# NEXUS

AT 1200 HOWELL

#3021813  
07.12.2016  
DRB RECOMMENDATION MEETING

**RESPONSE** TO EDG COMMENTS

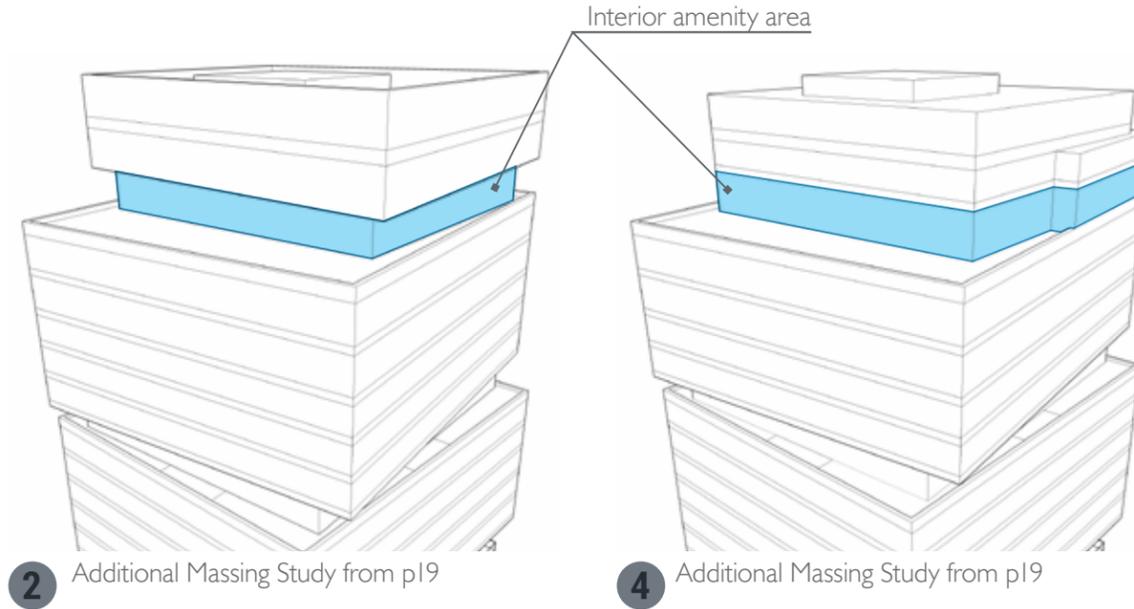
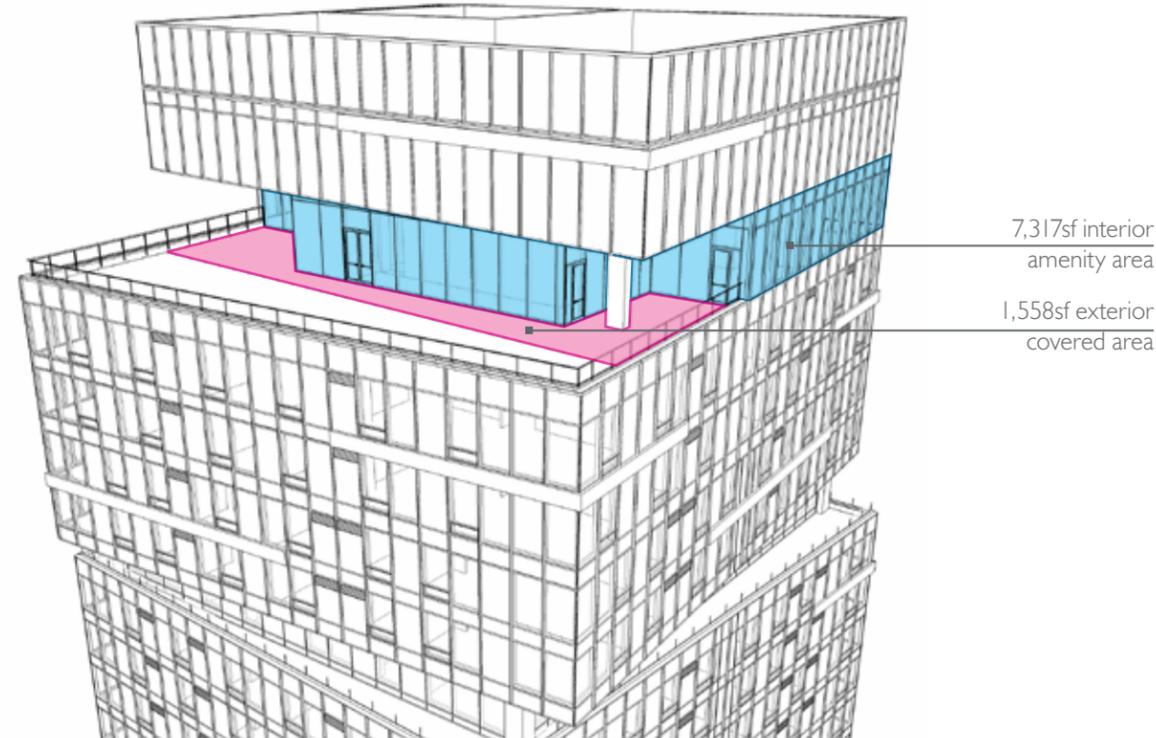
We request that our rooftop coverage exceed the 55% so the architectural precedent set up in the rest of the building can continue to its terminus and large covered areas can be provided on the rooftop deck

The total allowed rooftop coverage is 6,330sf (.55 x 11,509sf floorplate measured to the outside face of the exterior wall). Our enclosed amenity and core area on RI is 7,317sf, or 63.5% of the rooftop area. If outdoor covered space is included, the number increases to 8,875sf or 77% of the total rooftop. The request at EDG was 8,425sf of interior space, the Difference has been reduced by 1,108sf, or over 13%

After studying various roof forms and options per the Board's guidance, the current size and shape of the covered rooftop area is critical both functionally to the residents as well as aesthetically in defining the crowning element as a unified and important piece of the project. The large overhangs created match the erosions midtower and at street level, creating layers of unified language expressed from top to bottom.

As was shown in the Additional Massing Studies, the preferred design better meets Board direction of a better proportioned top of the tower. The Massing Studies above do not complete the top of the building in an elegant, coherent way
